From: Nancy McLaughlin  
To: Sara Roediger  
Date: 11/20/18  
Re: Project: Redwood at Rochester Hills Review #1  
Parcel No: 70-15-13-476-005  
File No.: 18-022 BESC18-0175  
Applicant: Redwood USA, LLC

From: Jason Boughton, AC, Engineering Utilities Coordinator  
To: Kristen Kapelanski, AICP, Planning Manager  
Date: September 5, 2019  
Re: Redwood at Rochester Hills, City File #18-022, Section 13  
PUD Plan Review #5

From: Kristen Kapelanski, AICP  
Date: 9/11/2019  
Re: Redwood at Rochester Hills (City File 18-022)  
PUD Concept Plan - Planning Review #5

**Subject: File No. 18-022 Redwood at Rochester Hills PUD  
Wetland Use Permit Review #5;  
Plans received by the City of Rochester Hills on  
August 27, 2019**

**CITY OF ROCHESTER HILLS**  
STANDARD DETAIL FOR:  
**Sight Distance Roadways**

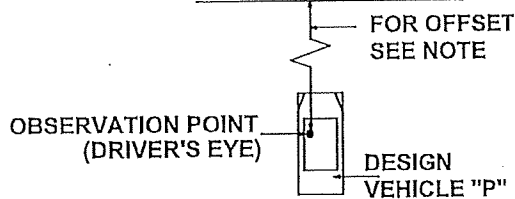
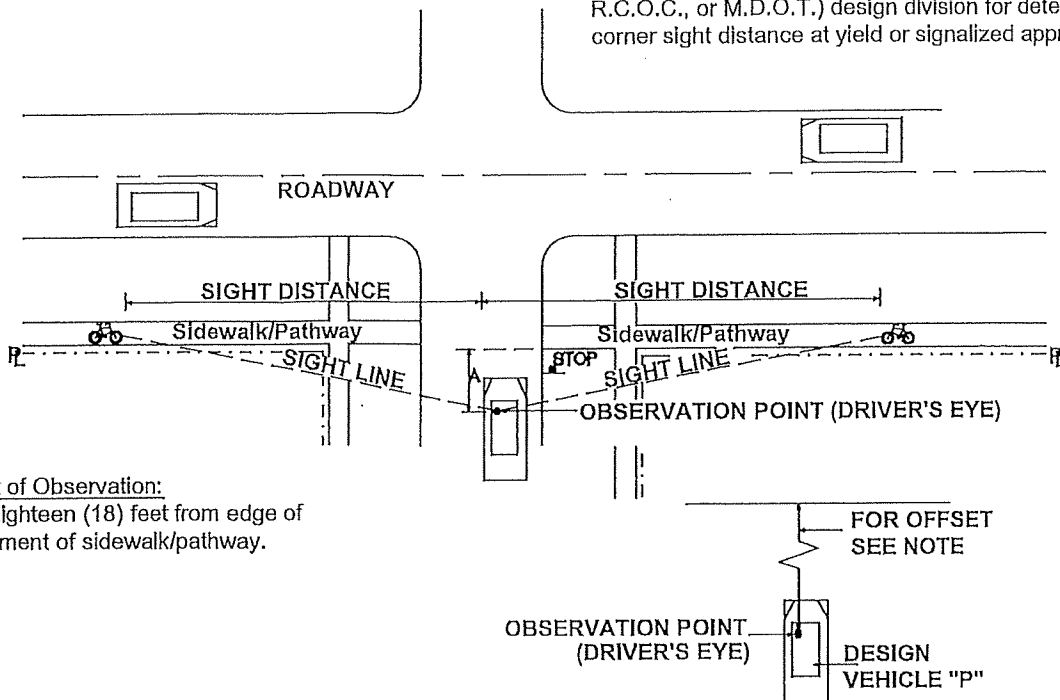
1. Awaiting approved RCOC ROW use permit and acknowledged by the developer. Provide a note on plans to this affect. Please note PUD approval will not be accepted until RCOC permit is received.
2. The right-in/right-out may need to be defined better to discourage motorists from entering/exiting incorrectly. MDOT detail GEO-680-B on sheet 4 of 6 may apply. Again, we are reviewing the plans in conjunction with RCOC roundabout plans and do not anticipate any conflicts between the two related drive locations. This comment will remain until complete but does not affect conditional approval.
3. The road and pathway sight lines at each approach should be shown on the Landscape plans (which were not included in plan set). The sight lines must be unobstructed, per details, by any existing or proposed objects (CITY detail attached).
